Mechanical Addendum M-1

Date: August 30, 2023

Project: **Centre For Addiction and Mental Health
Move Consolidation – Interior Renovations**
250 College Street,
Toronto, Ontario,
M5T 1R8

Subject: Mechanical changes and/or additions

1 DUCTWORK FITTINGS AND BALANCING DAMPER DETAILS
M-103 N.T.S.

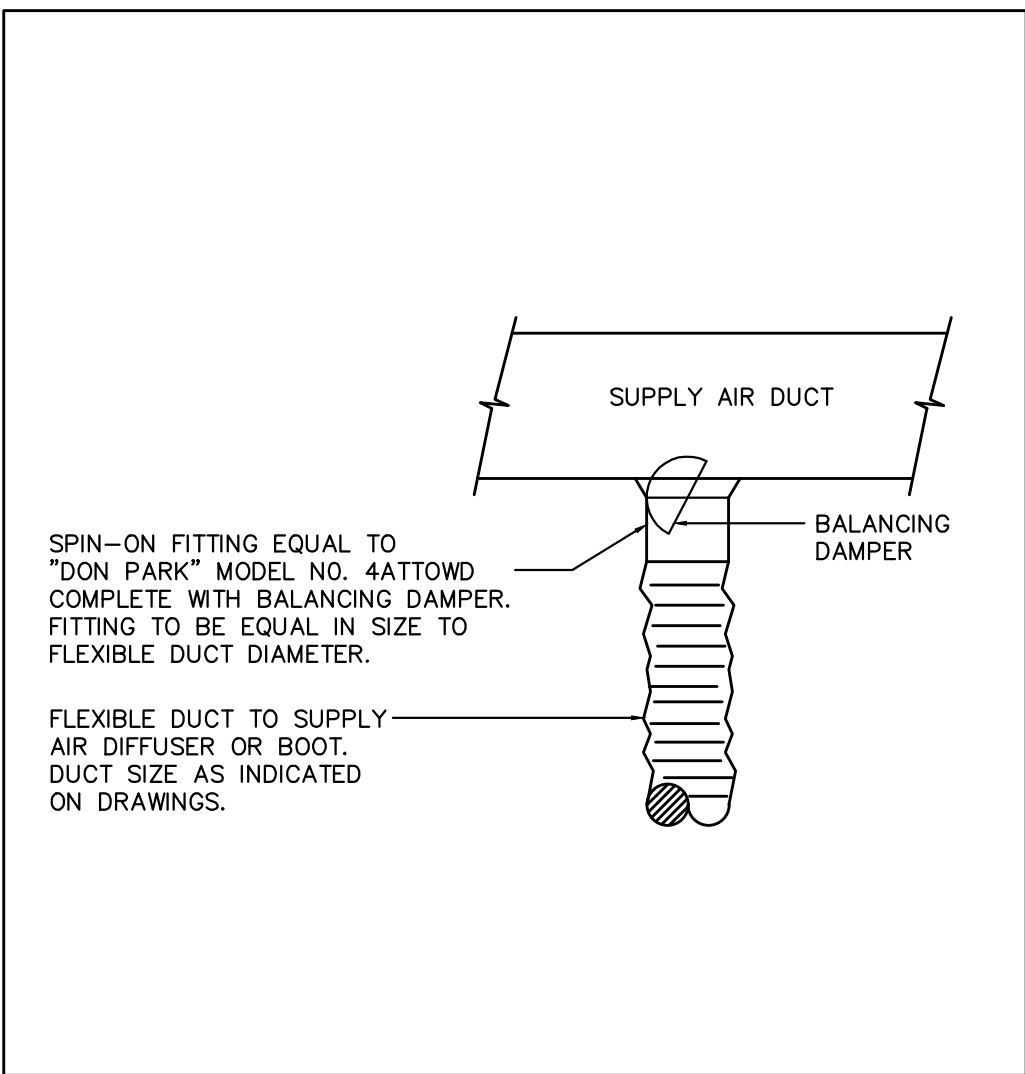
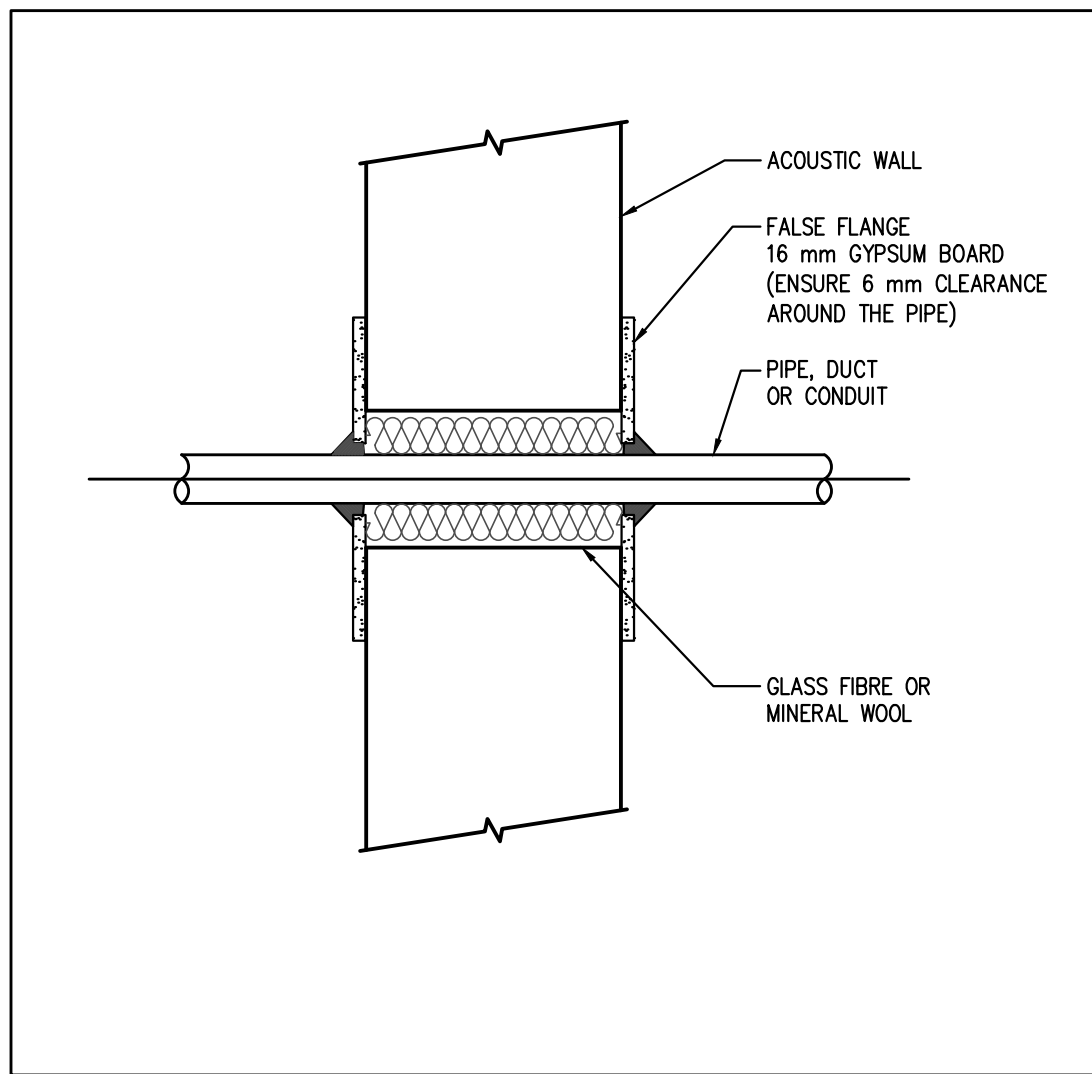
1. Mechanical drawing has been updated to reflect the EF-3 Service Area, and updated note for Detail 5/M-103.
3. **Drawing M-105, Mechanical Details and Equipment Schedule (Issued)**

M-105

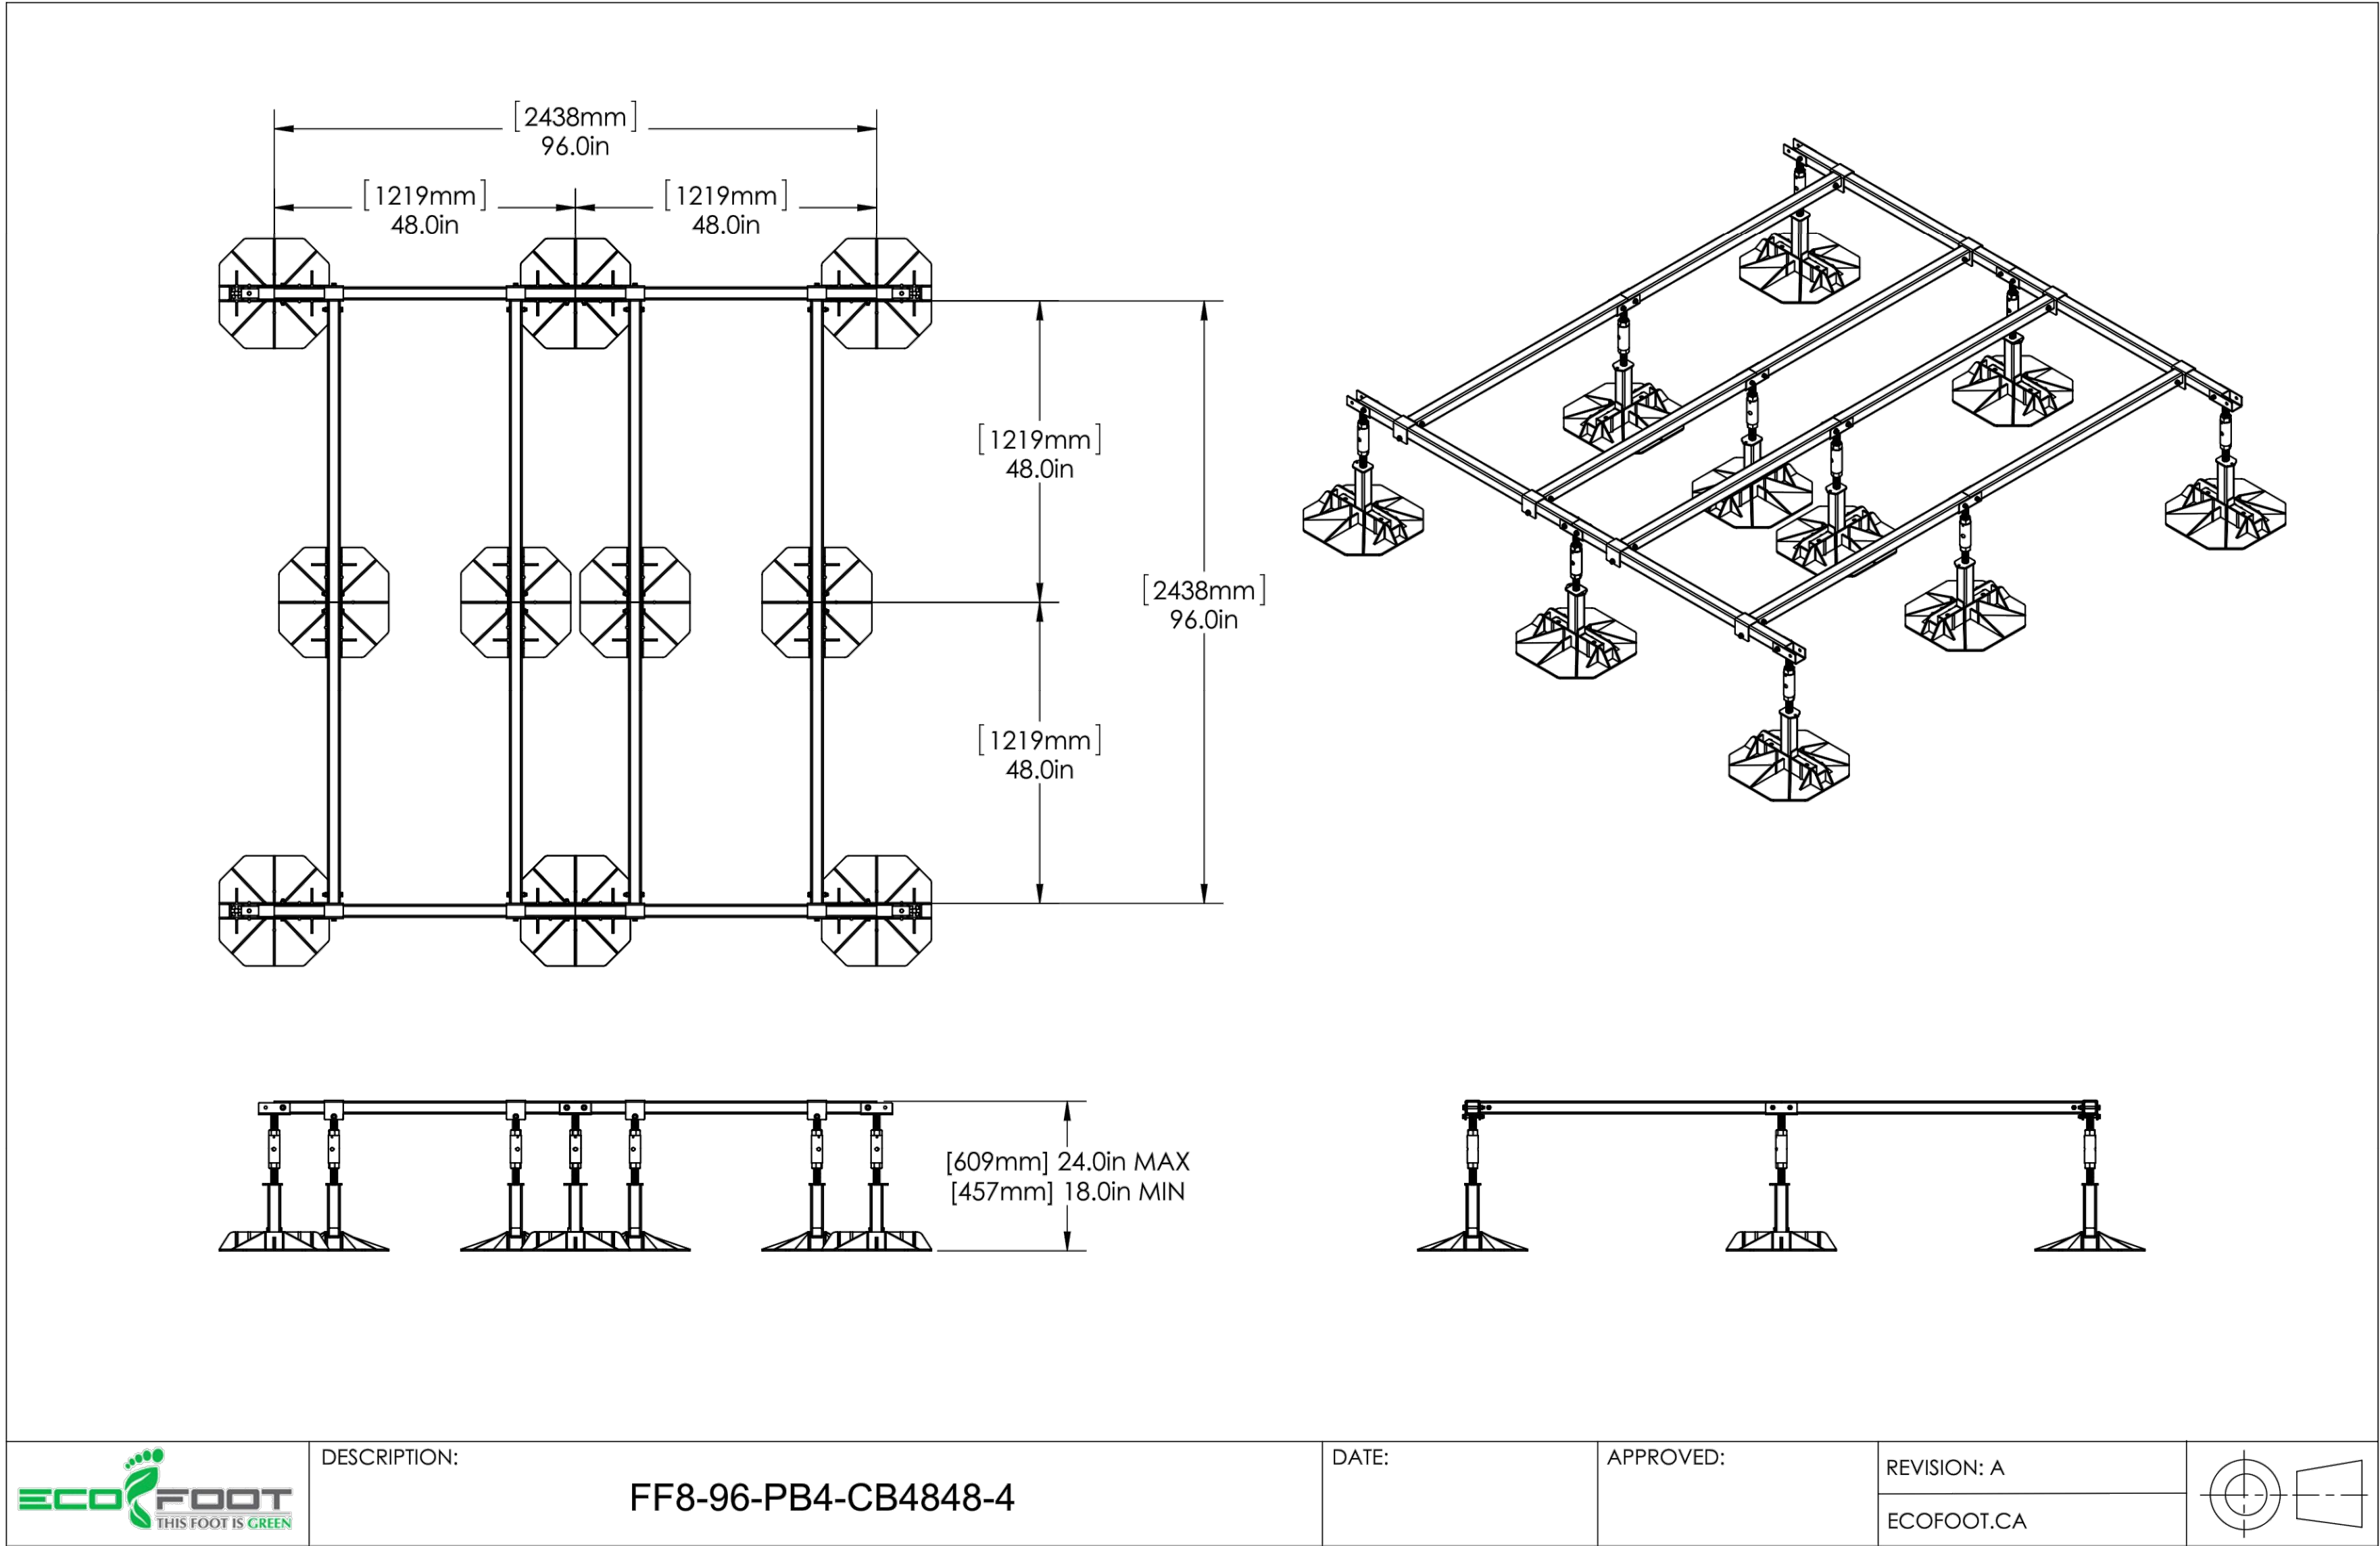
1. Mechanical drawing M-105 has been added to the mechanical set to reflect the condensing unit support detail, new supply and return air grille schedule, and new condensate pump schedule required for CAMH provided portable AC units.

01 NEW LAYOUT - GROUND FLOOR (NORTH) PLAN
M-200 1/8"=1'-0"

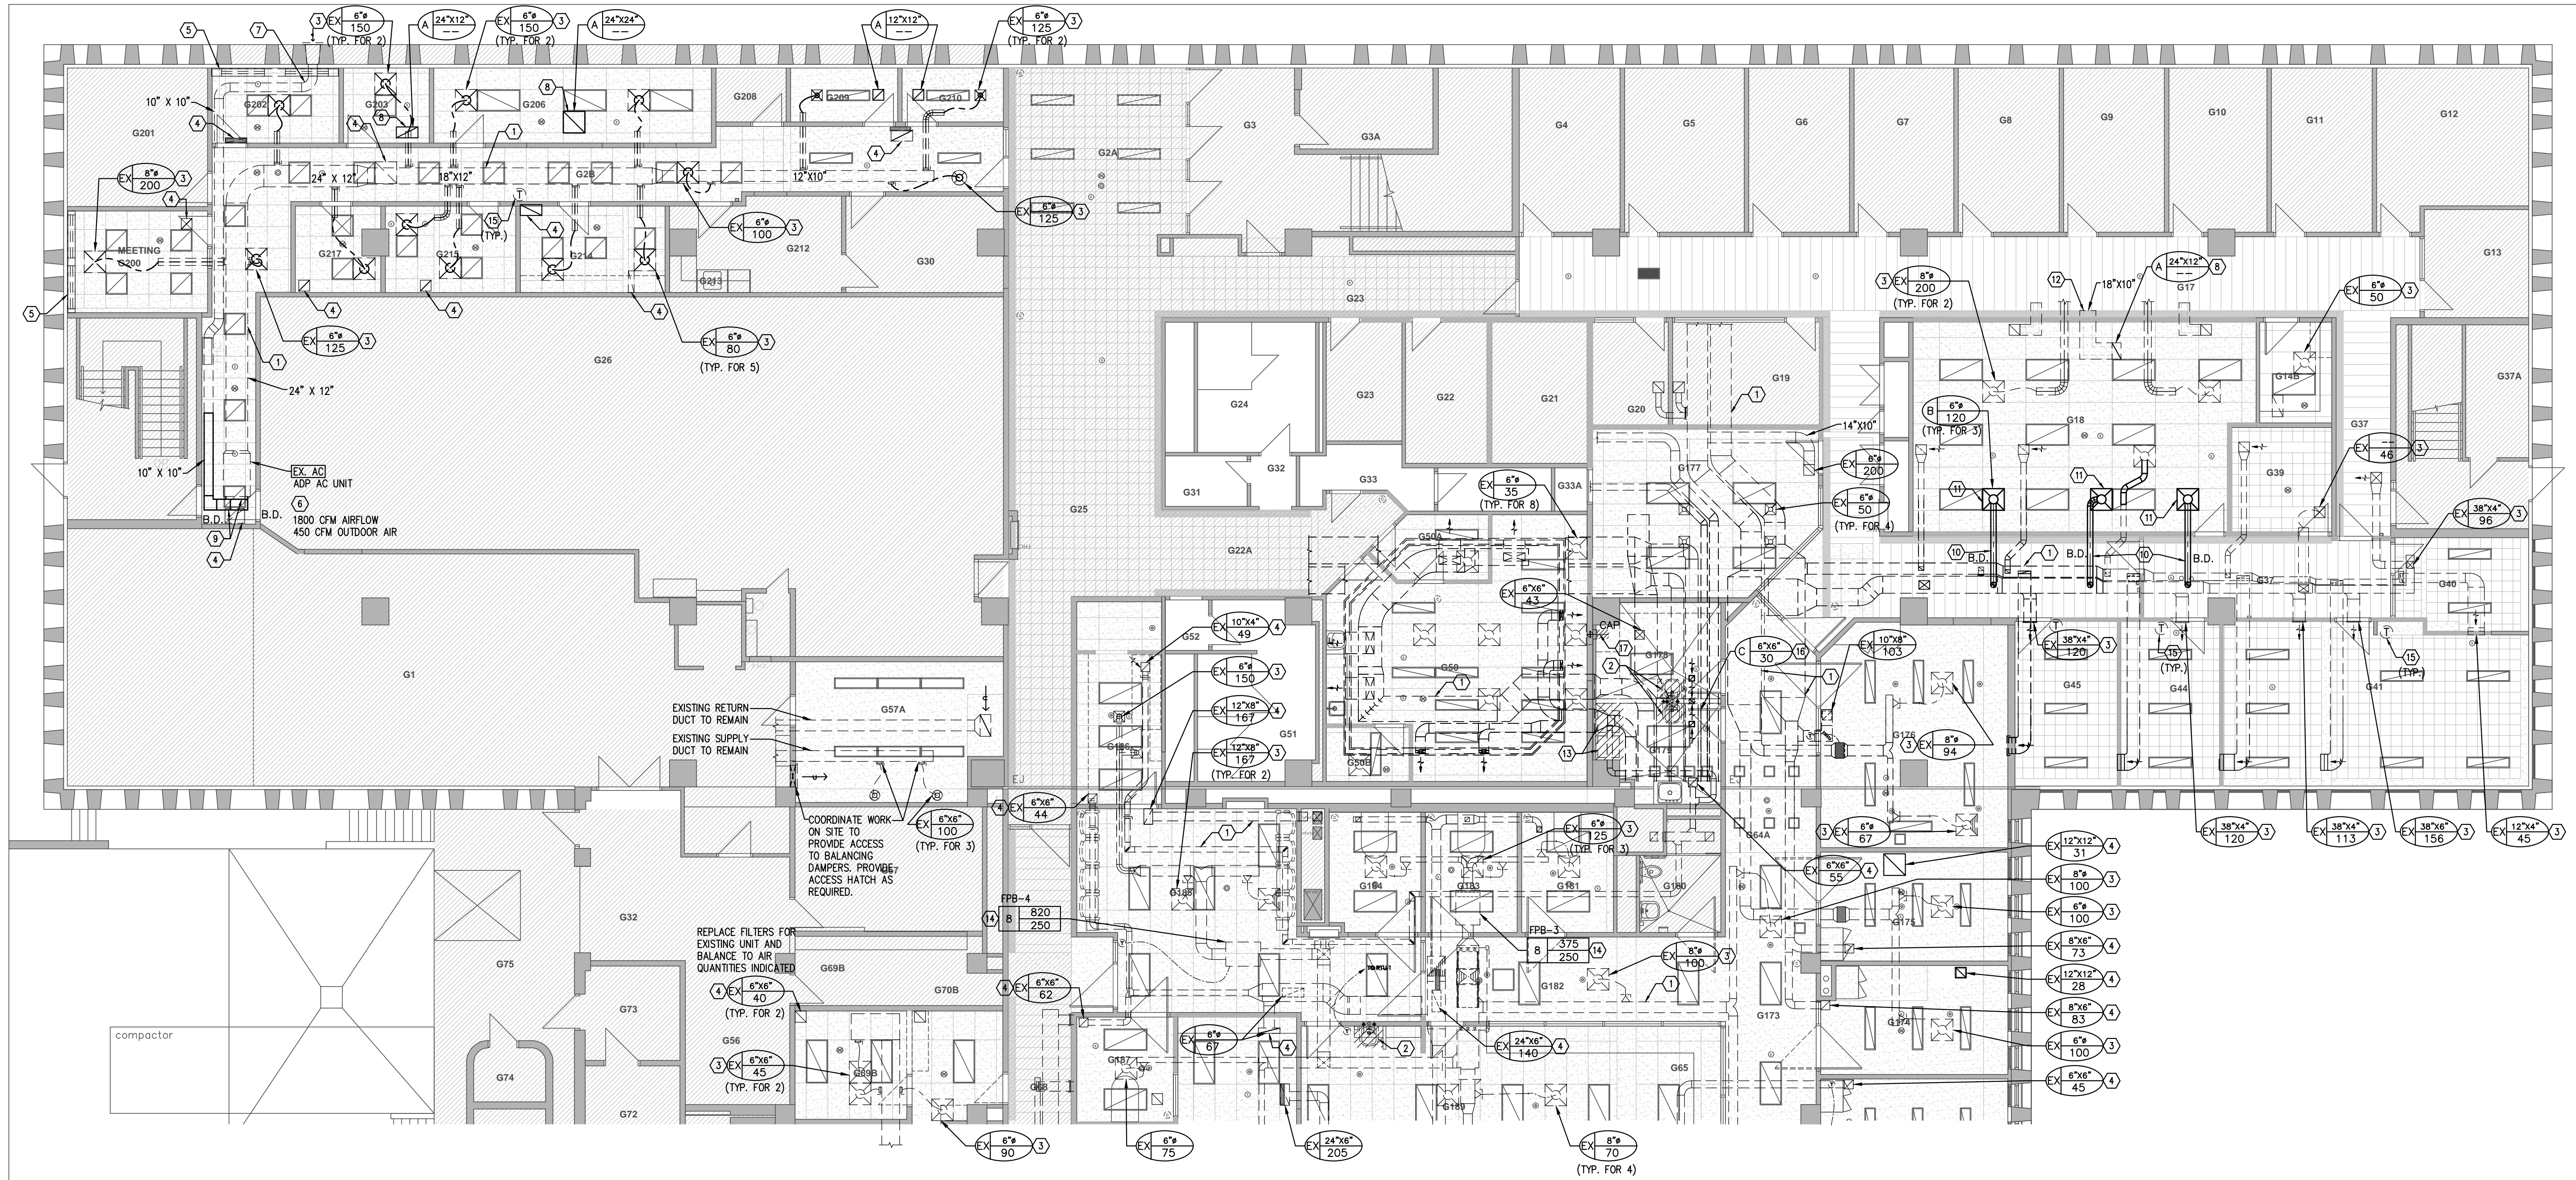
4. **Drawing M-200, Mechanical Plan – Ground Floor North Plan (Issued)**
 1. General Revisions have been made to the mechanical drawing. Refer to drawing notes.
